1.1 ADDENDUM

.1 The following changes to the specifications and drawings are to be incorporated in the Tender Documents.

SPRINGHILL SERVICE CENTRE RENOVATIONS

ASK-1

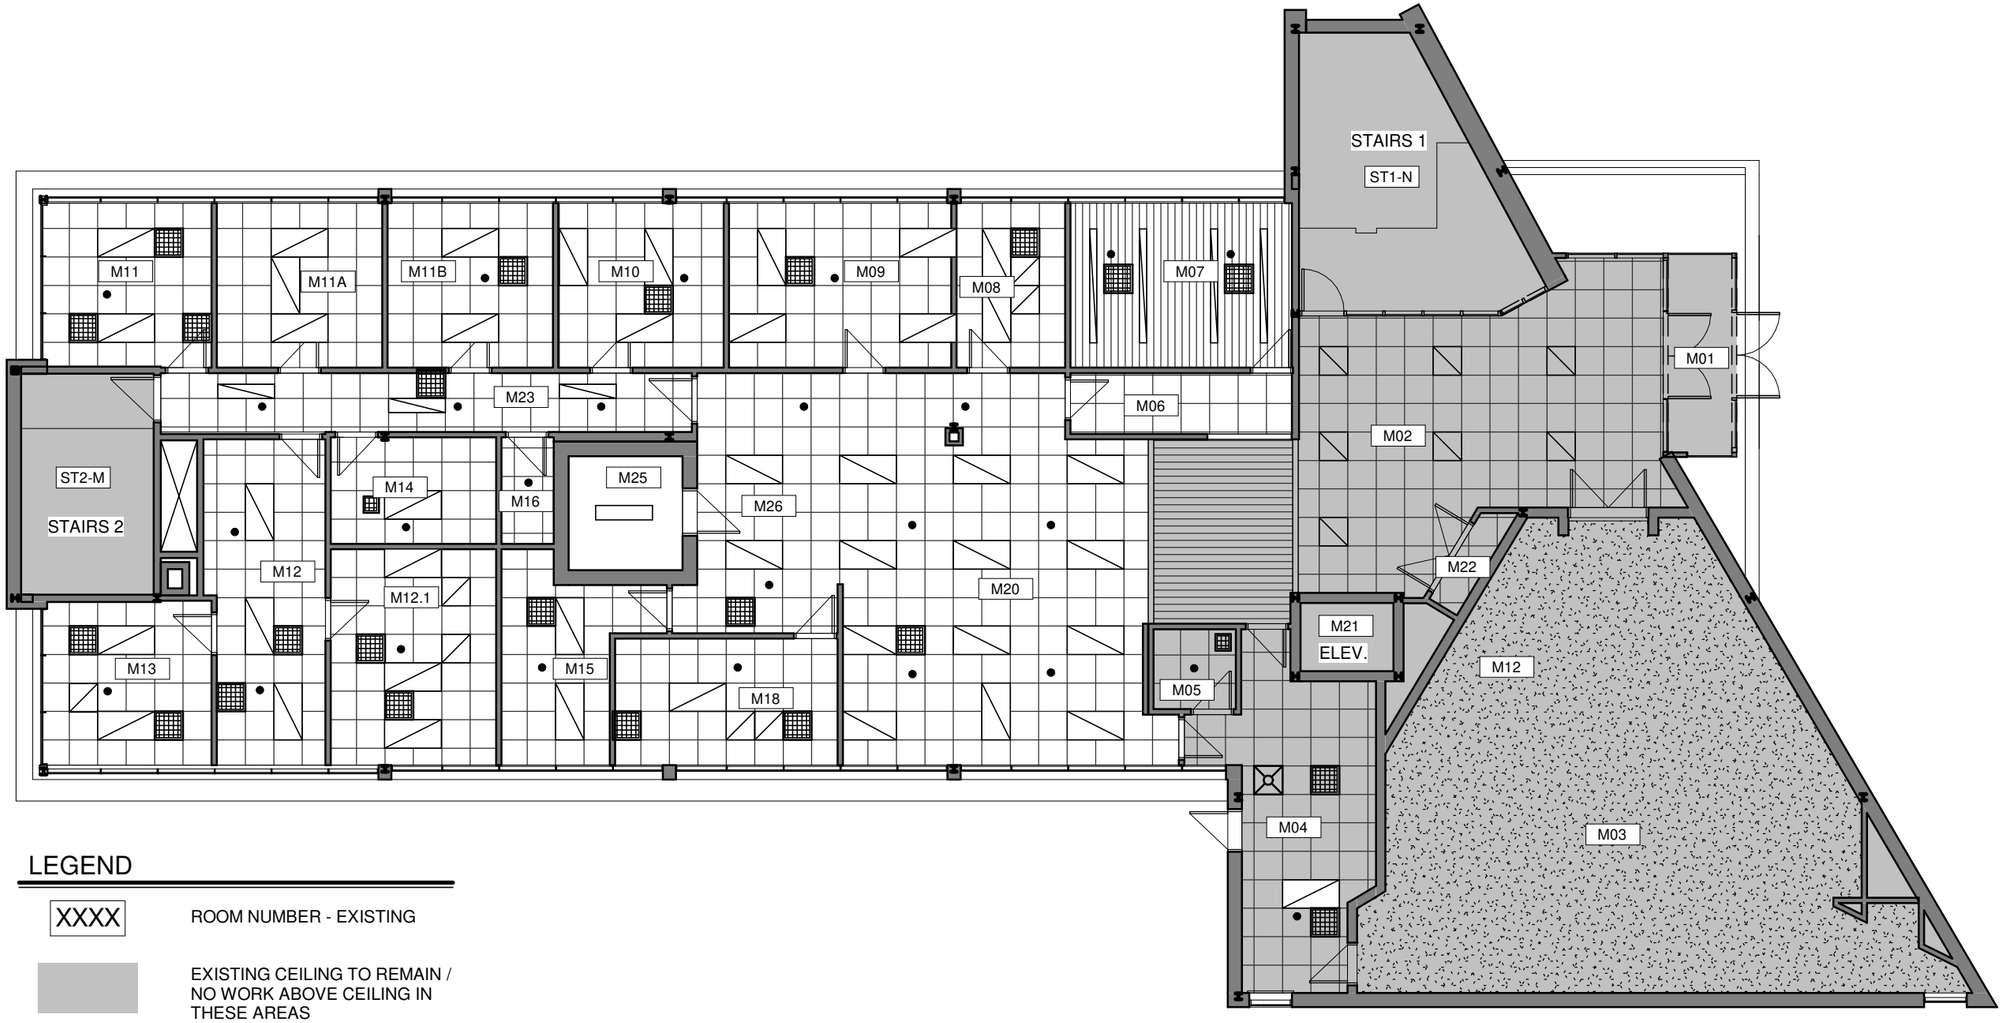
.2 Refer to the following sketches for existing ceiling plans. Existing conditions may vary from what is shown on these drawings and are intended for Information Only:

.1 ASK-1 EXISTING CEILING PLAN - MAIN FLOOR, dated 2020-04-02.

ASK-2

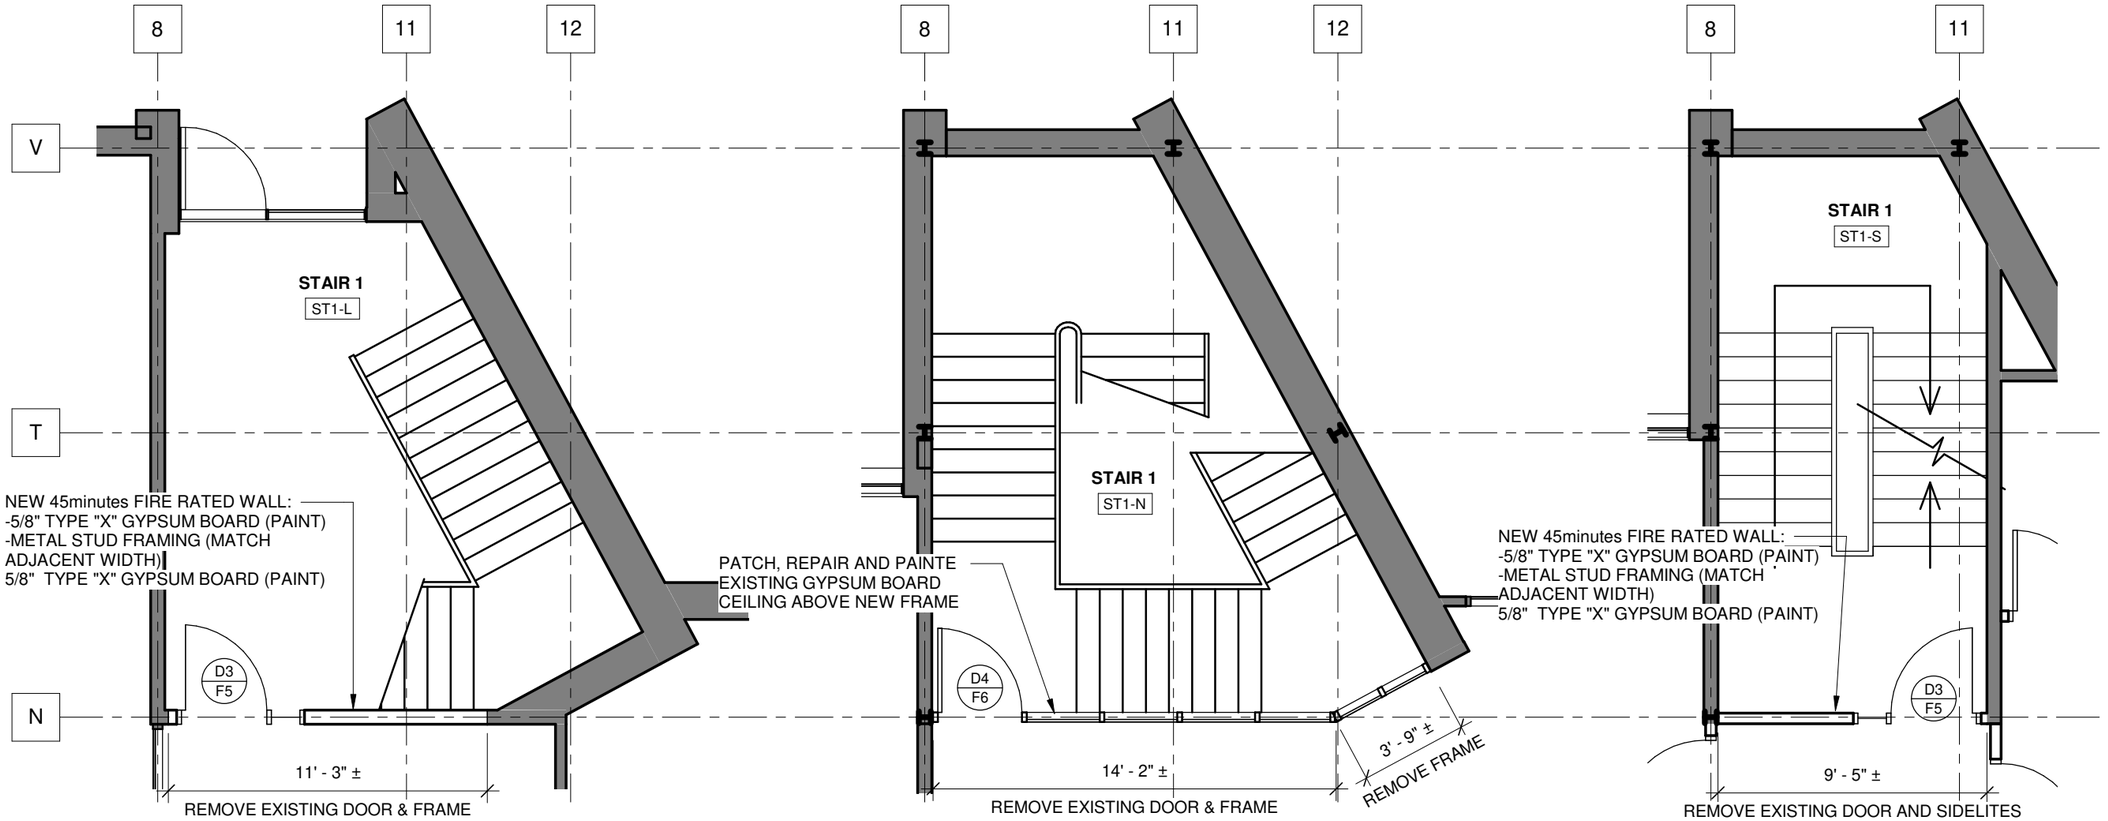
.2 ASK-2 EXISTING CEILING PLAN – LOWER FLOOR, dated 2020-04-02

ASK-3

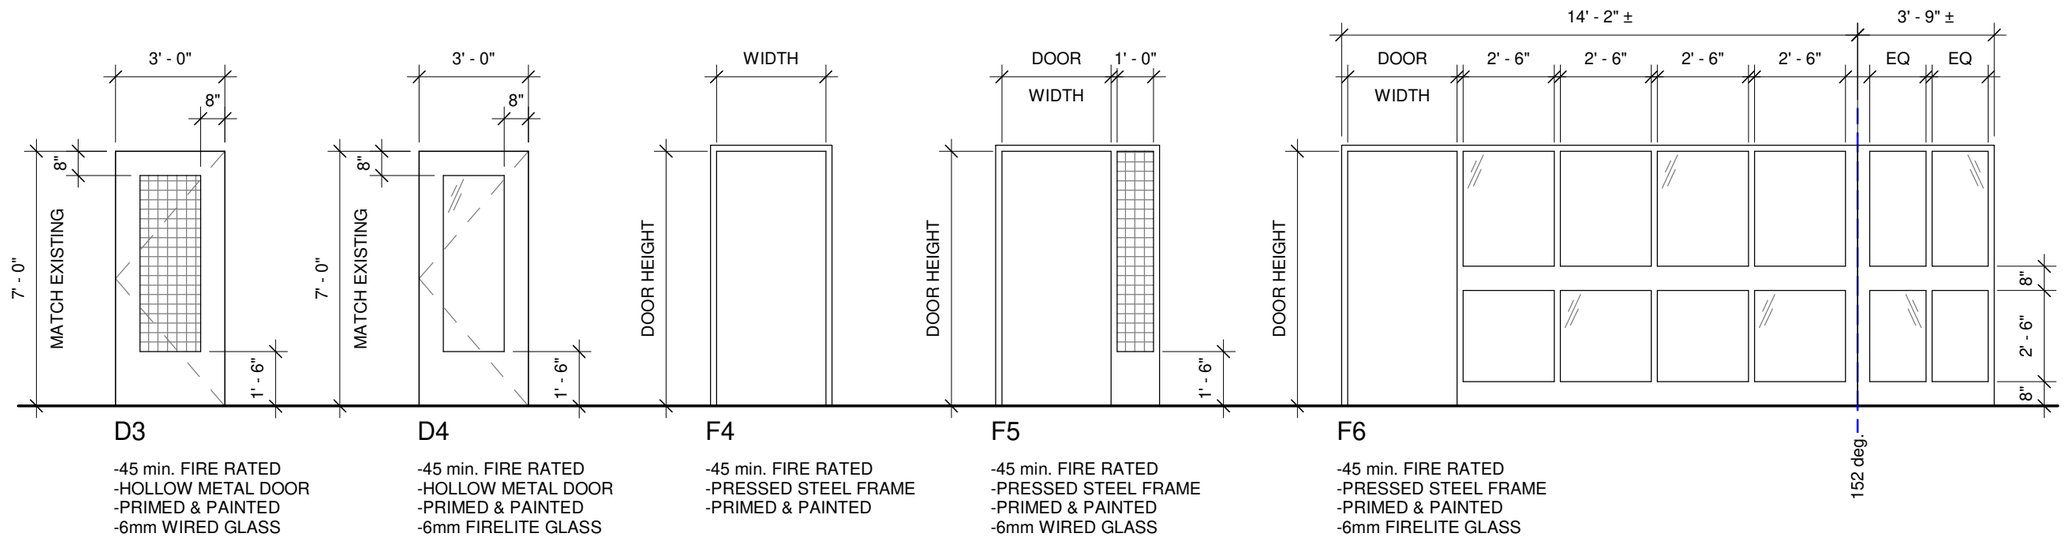
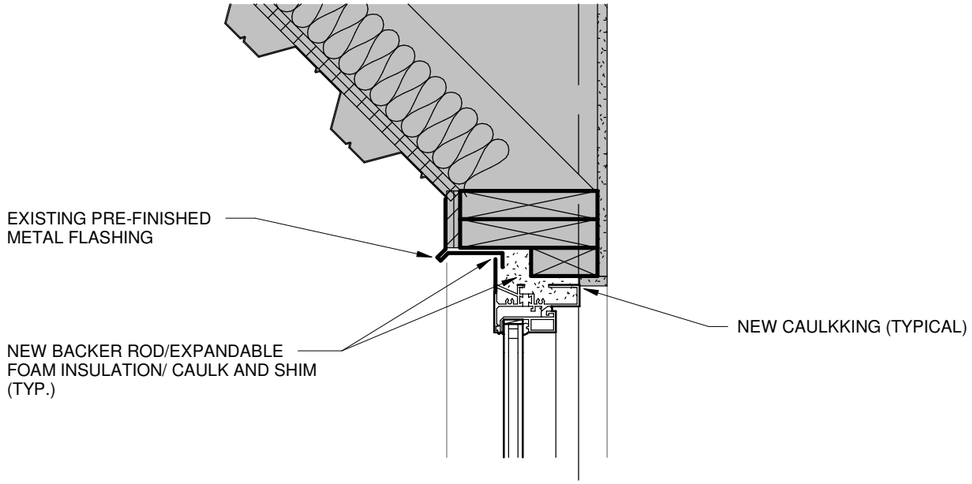
.1 Existing door & frames leading to Exit Stair #1 from Lower, Main & Upper Floors are to be removed and replaced as per attached ASK-3, complete with new hardware as follows:

.2 Existing door & frames leading to Exit Stair #2 from Lower, Main & Upper Floors are to be removed and replaced with new door type “D3” and new frame type “F4”, as per attached sketch ASK-3, , complete with new hardware as follows:

.1 Lower & Main Floor:

.1 Hardware Set 13.0

.2 Upper Floor:

.1 Hardware Set 11.0.

.1 Lower & Main Floor:

.1 Hardware Set 13.0

.2 Upper Floor:

.1 Hardware Set 11.0 - As per original contract documents.

ASK-4

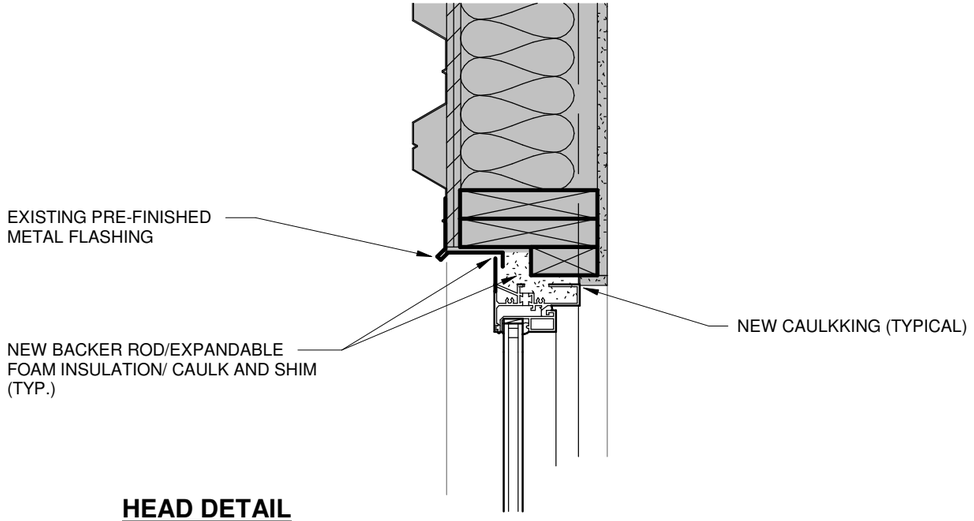
.1 Refer to the attached sketch ASK-4 – WINDOW SECTIONS, dated 2020-04-02, for details in reference to the Alternate Price stipulated in this addendum.
